Upgrading the footpaths and surrounding environment on Midsummer Common: a summary of our recommendations

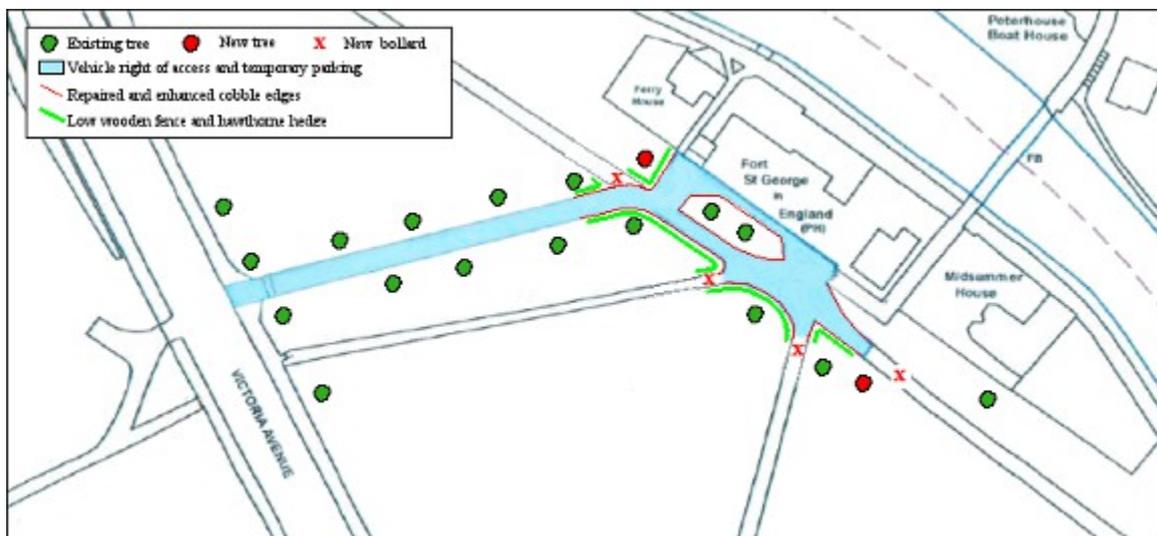
1. Environmental enhancement of the Fort St George area. The continuing problem of illegal driving and parking around the Fort St George pub and Midsummer House restaurant has resulted in widespread environmental degradation of the Common. Parked vehicles are an eyesore and barrier to pedestrian and cycle movements. Ways must be found to keep vehicles within the designated area and not to outstay their welcome. Whilst the paths are generally fit for purpose, environmentally sensitive and high quality measures must be taken to prevent vehicles leaving the paths and driving and parking on the grass.

The Council recently negotiated rights of access and parking with the pub owner and this should be the starting point. We **recommend**:

- a) Restoring and extending the cobbled edges to the paths at the most vulnerable corners;
- b) Planting some low hedging and protective fencing to discourage illegal driving and parking on the grass;
- c) Planting two trees to reinforce the driving restrictions;
- d) Pruning the trees immediately outside the FSG to ease movements and improve views across the Common;
- and
- e) Installing removable bollards along cycle/pedestrian routes to stop vehicles exiting over the grass.

A detailed plan of our proposal is shown below.

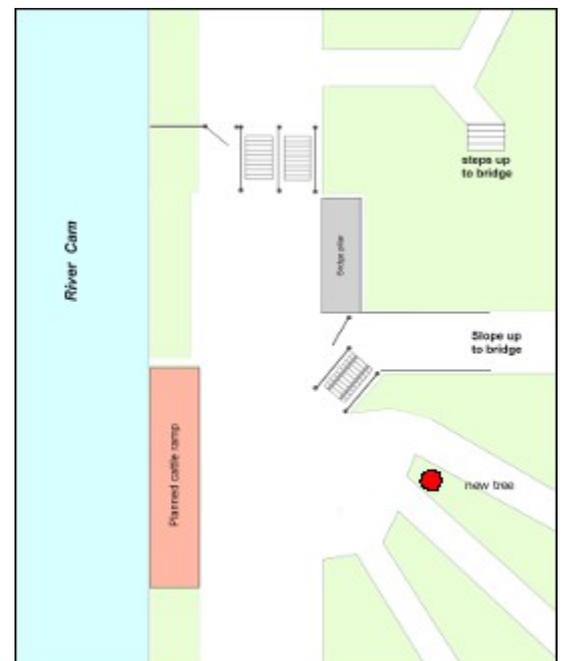
3.3 The intersection at A. Four footpaths converge on the Cutter Ferry Bridge from the west (two of these are public rights of way, one of the others is our footpath to Maids' Causeway), two footpaths converge from the east (one is a public right of way), and the bridge brings pedestrians and cyclists across the river from Chesterton. It is a very busy junction for cyclists, pedestrians and push chairs; daily bike counts are over 1,200. Grazing cattle on the Common dictate the need for gates and cattle grids in this area.

The current junction layout is hazardous. Pedestrians and push chairs must cross the bike lanes to use the gates. Cyclists travelling in both directions along the river bank must cross the same cattle grids twice. Many posts in the path give a challenging barrier to movement. Those coming off the bridge are fed at right angle past a blind spot straight into this two-way traffic. Users, cyclists in particular, have asked for improvements to the layout in order to ease congestion and improve safety. However, where mixed transport must share a space it might be better not to free things up so everyone is obliged to slow down and be prepared to give way.

We **recommend** a fundamental review of this intersection. One might consider (see sketch plan on right):

- a) A single gate for pedestrians (in line with the new gate installed at Walnut Tree Avenue);
- b) Two cattle grids in parallel for cyclists travelling in opposite directions (in line with the grids installed at Walnut Tree Avenue). Cattle grids to have a proper internal ramp to enable easy escape for any trapped wildlife;
- c) To reduce conflicts for those coming off the bridge, the base of the slope might be redirected away from the cross traffic and a cattle grid with pram irons and pedestrian gate inserted (as on the footbridge next to the Fort St George pub). Space can be reserved for the City Council's proposed cattle ramp;
- d) Planting of a tree and cattle guard to the rear of the new litter bins to integrate these large features better into the Common landscape; and
- e) At all times, high quality design detailing should be adhered to.
